Sandy Shores Canal Owners Request **Denial** of Powell Permit Modification Request

Notice of Non-Compliance
Boat Dock and Seawall Permit Condition Violations
Permit Nos.: BD-23-09-122-EXT and SADF-23-09-022
Site Address: 12023 Sandy Shores Dr.
Parcel ID No.: 24-23-27-7808-00-083

EPD photograph from compliance inspection on May 6, 2025

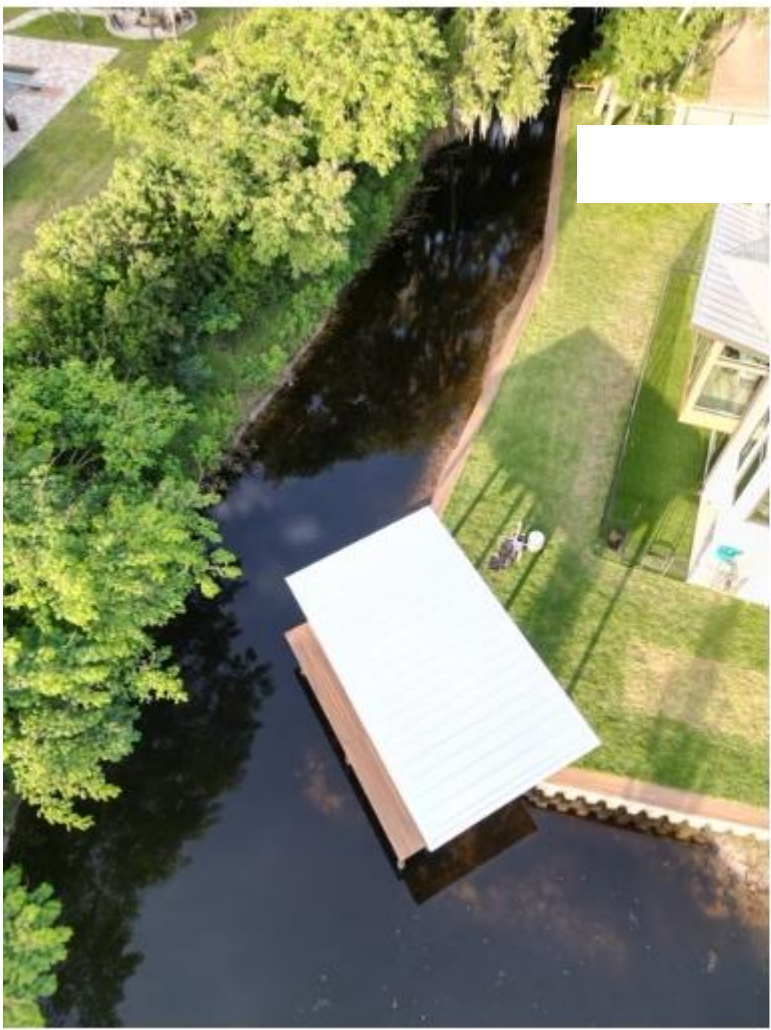
Inner edge of
walkway per
County approved
permit drawings.

East End of seawall
protrudes 3 feet
farther into canal
than permitted.

Permitted
location for east
end of seawall

EPD photograph from compliance inspection on May 6, 2025

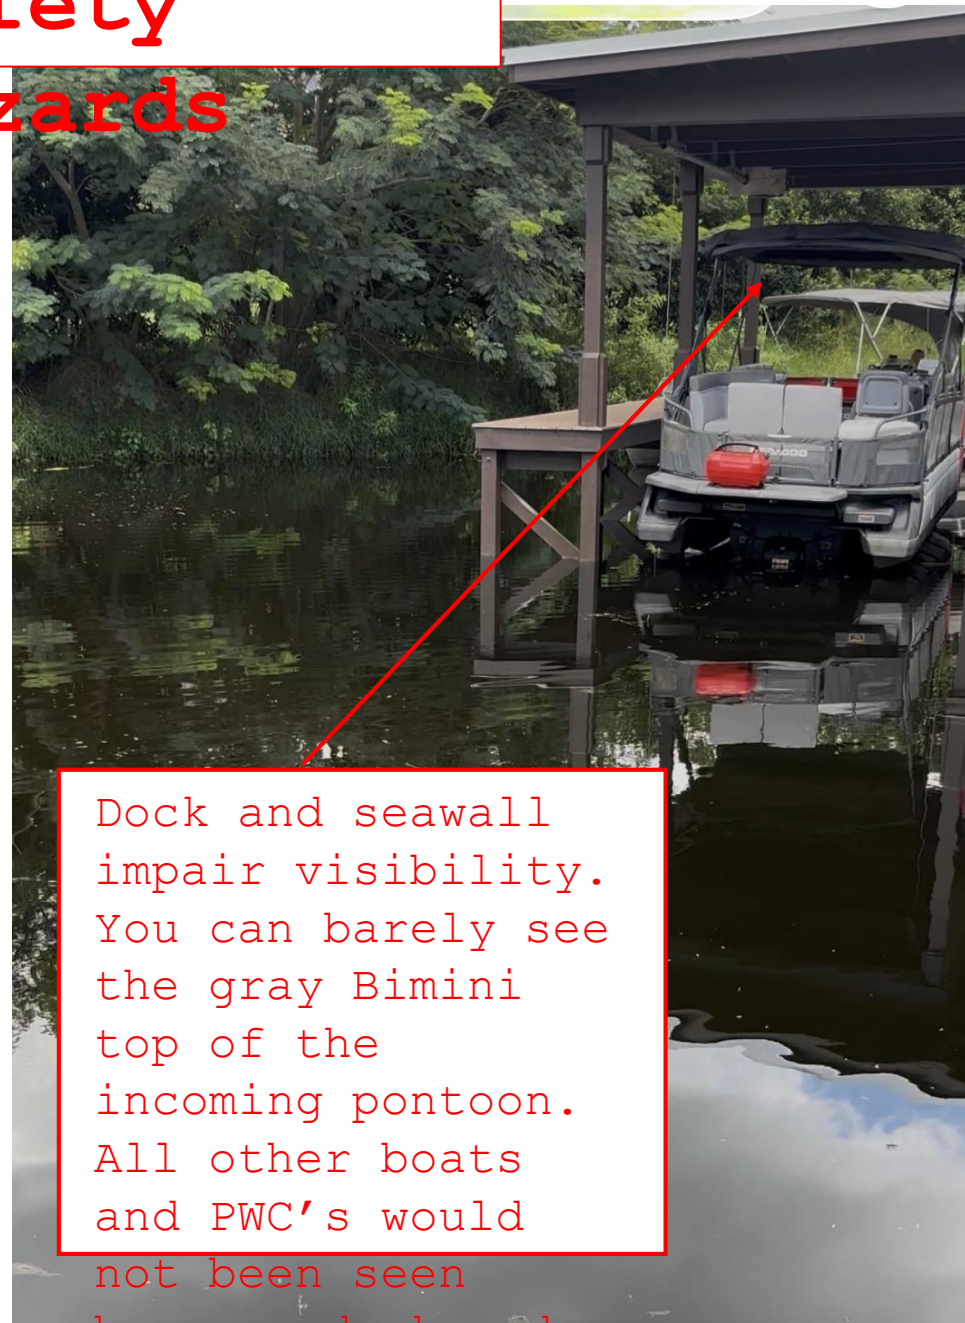
Seawall and dock impedes
navigation

Height of seawall and dock prevent visibility around corner. Seawall 2.5' higher than recommended by Orange County Stormwater Management

Tight point at NW corner of dock and canal

Enlarged snapshot
showing dock corner
25' from NHWE

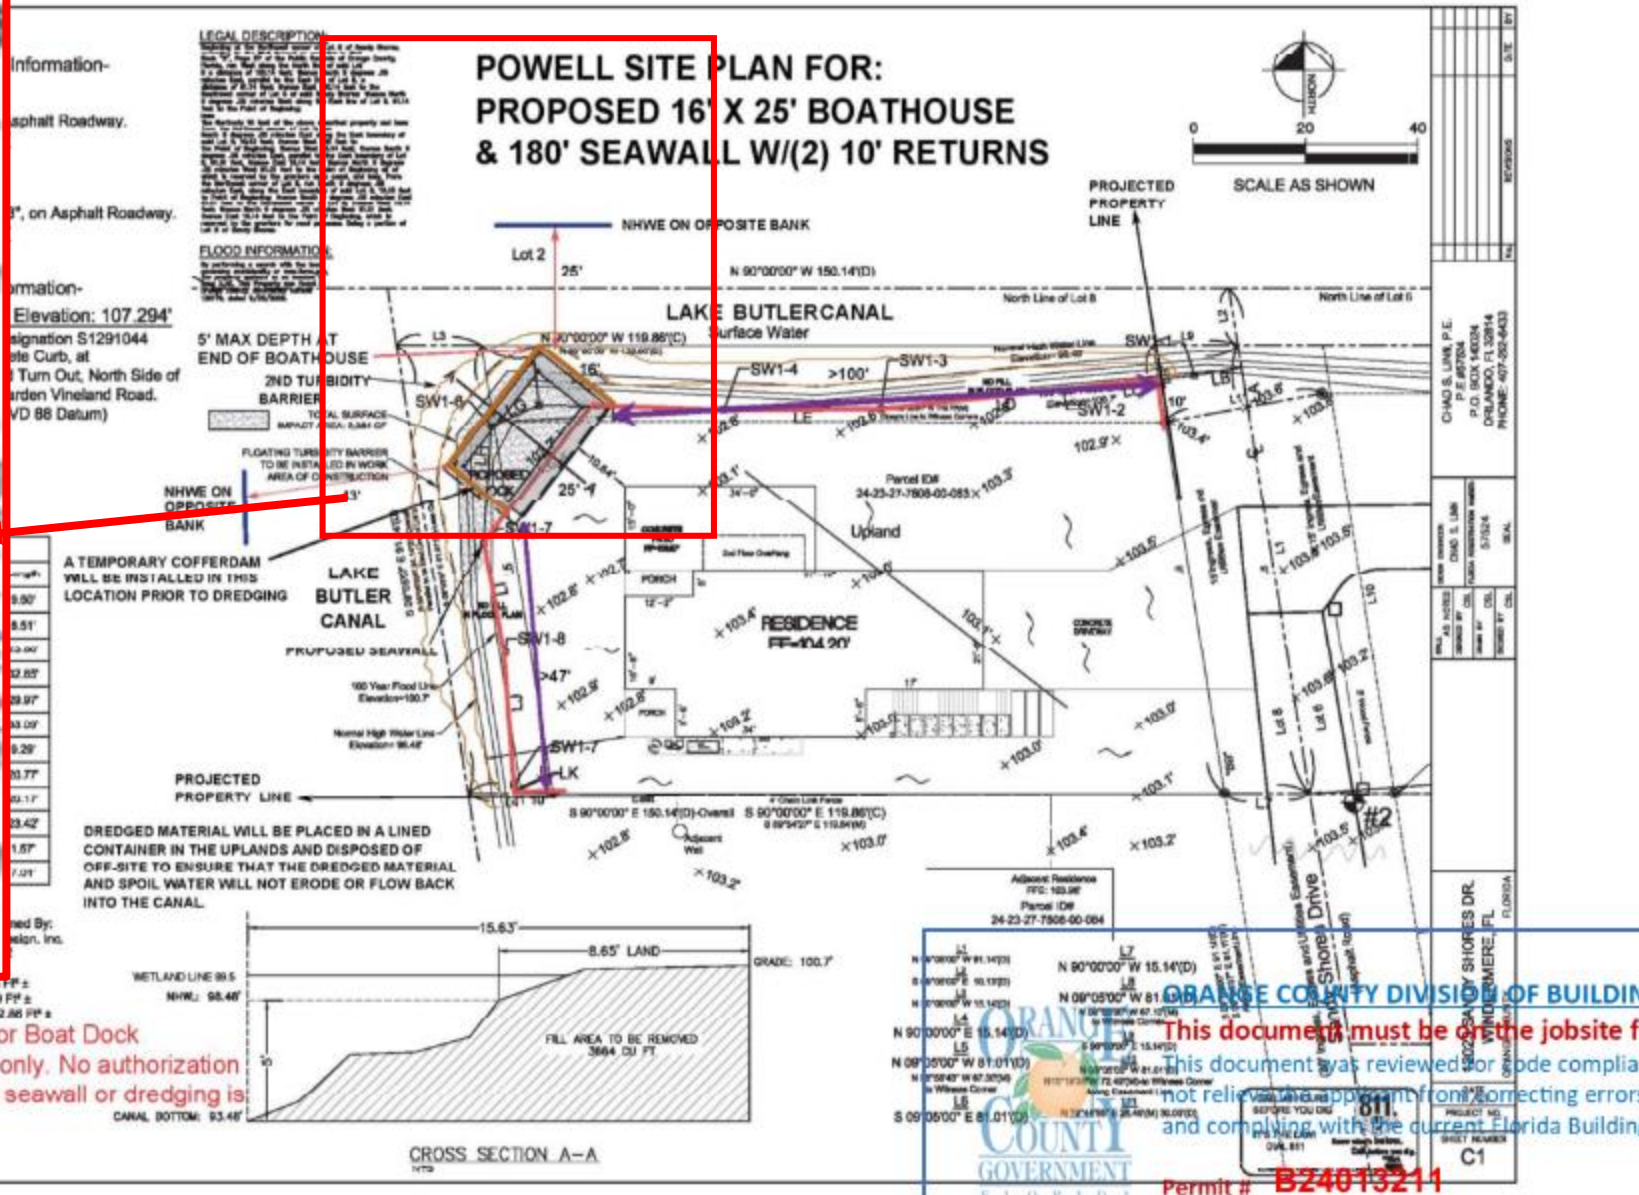
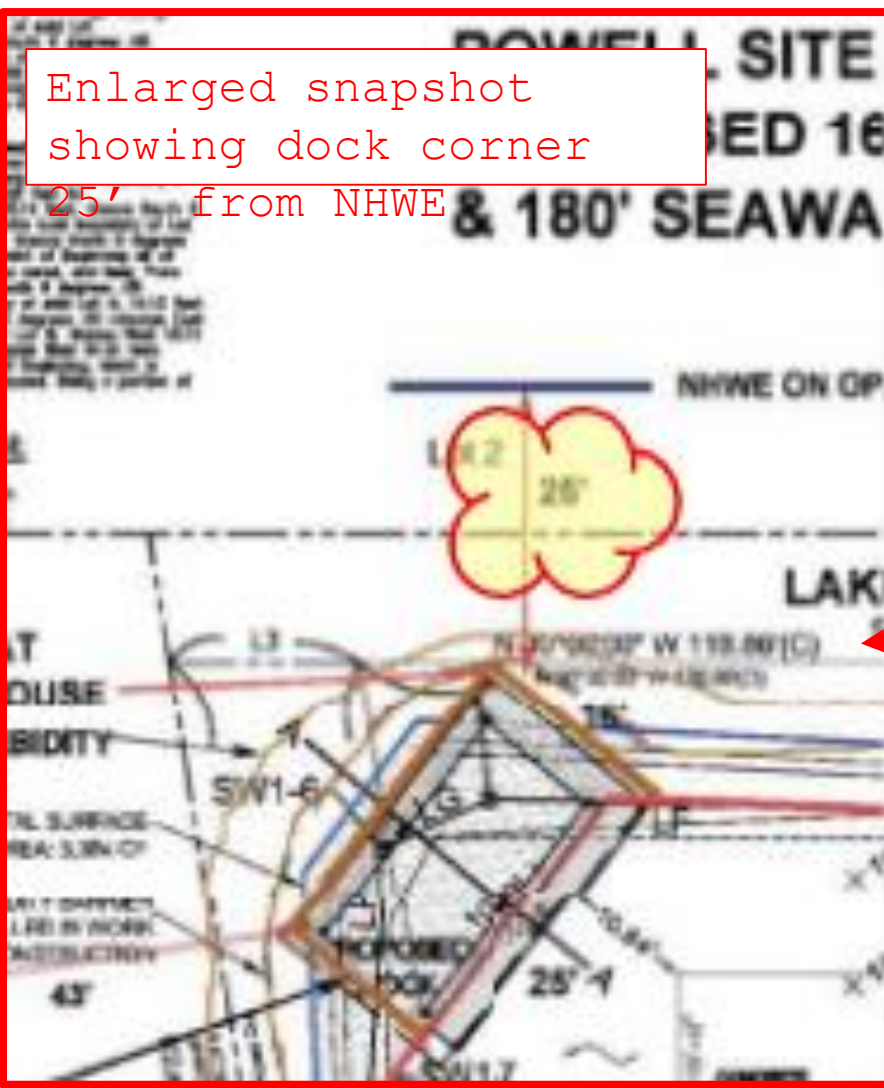
Corner of dock 4'-6" too far into canal and cantilevers 4'+ from support posts creating safety hazard for boats and watercraft

Dock and seawall impair visibility. You can barely see the gray Bimini top of the incoming pontoon. All other boats and PWC's would not been seen because dock and

SPECIFIC PURPOSE SURVEY

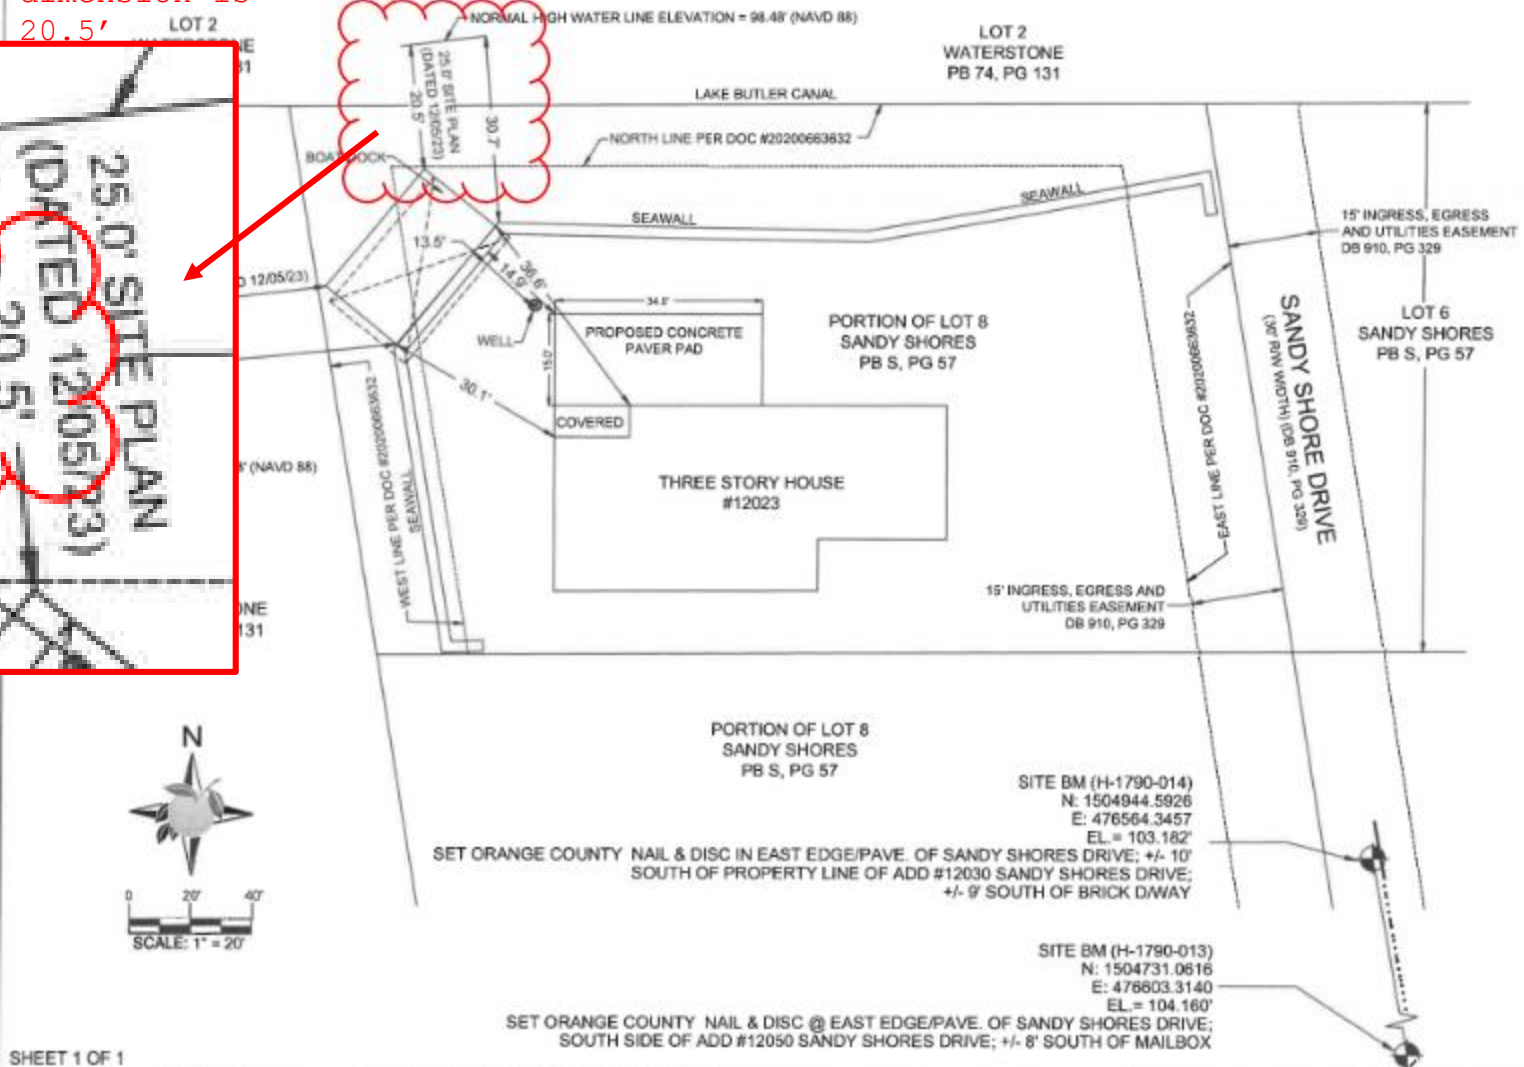
Permitted dimension shown requires 25.0' actual dimension is 20.5'

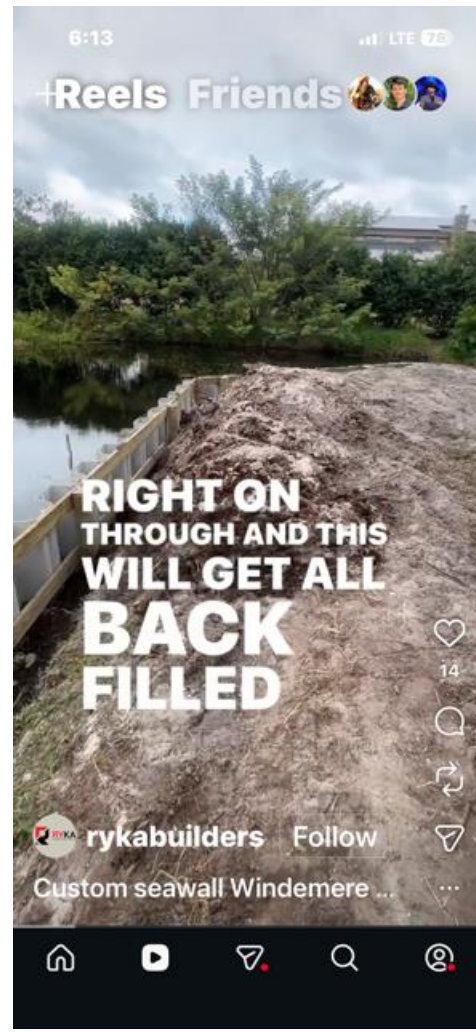
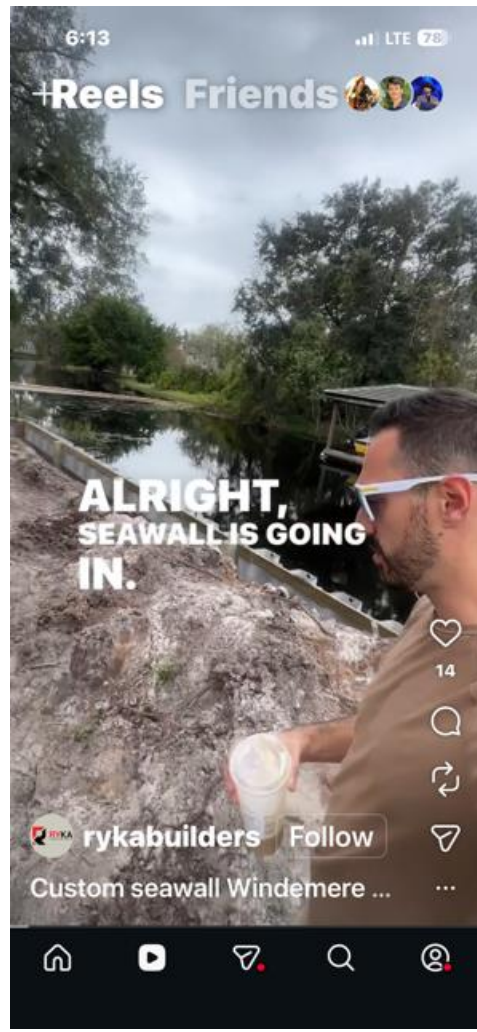
Inspection could not be completed due to fully back-filling seawall prior to inspection. Only way for Orange County to inspect will be for footer-tiebacks to be dug-out for inspector to review. This was never done.

There are no tie-backs in any of the pictures. Were they installed? We hope so!

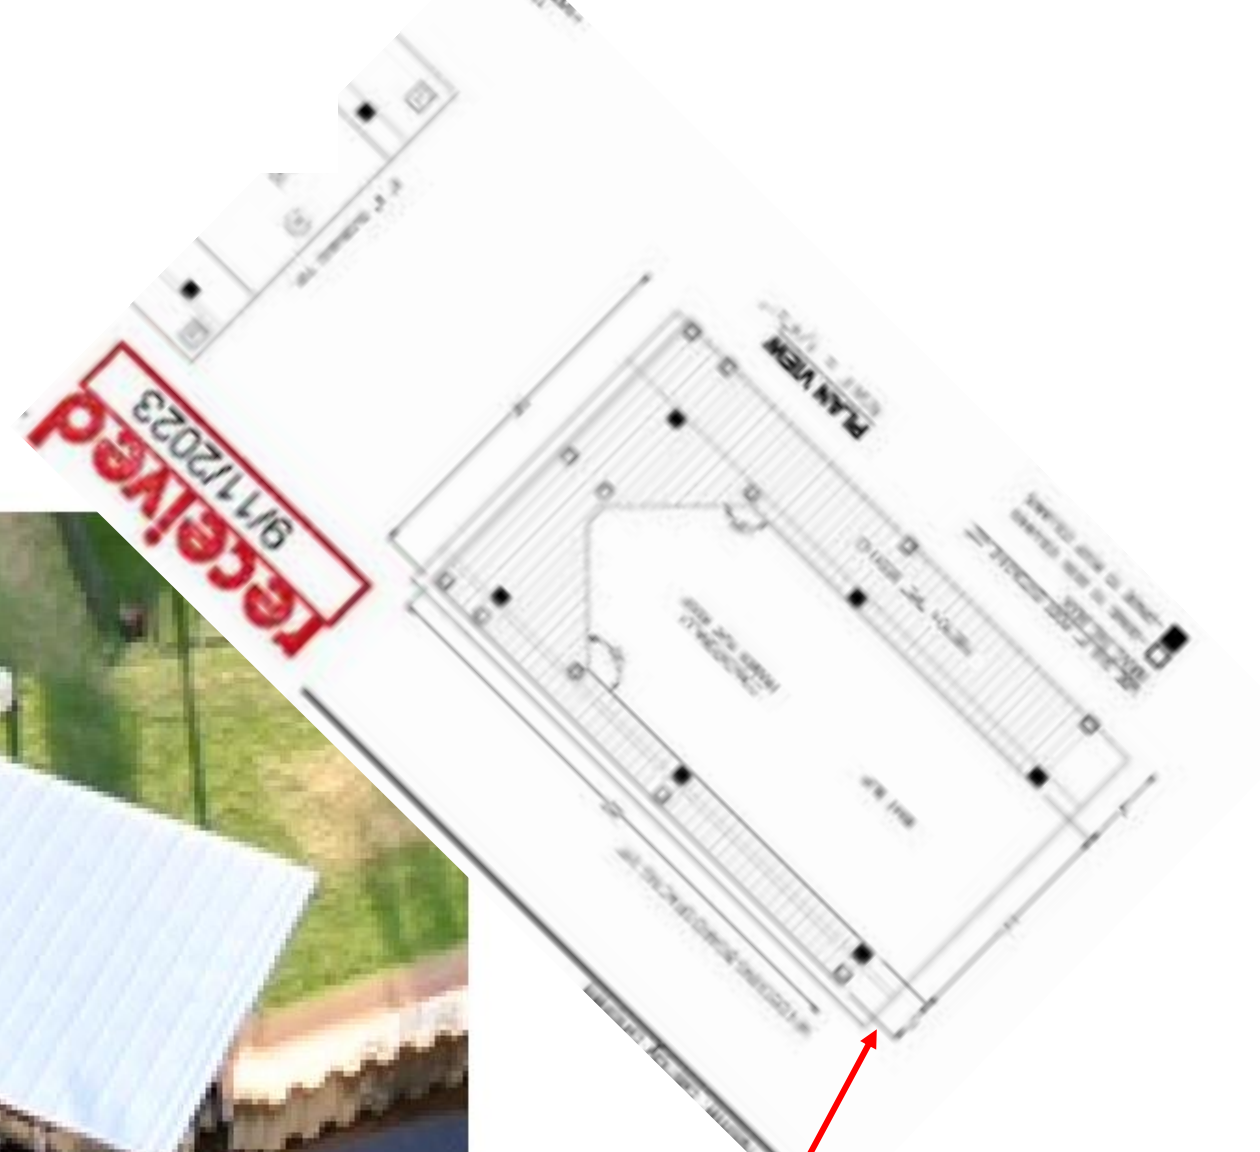
Dangerous cantilever

Canal side walkway 4'
in lieu of 2'

Dock permitted with
2' walkway, per
approved plan

Inadequate soil control during construction
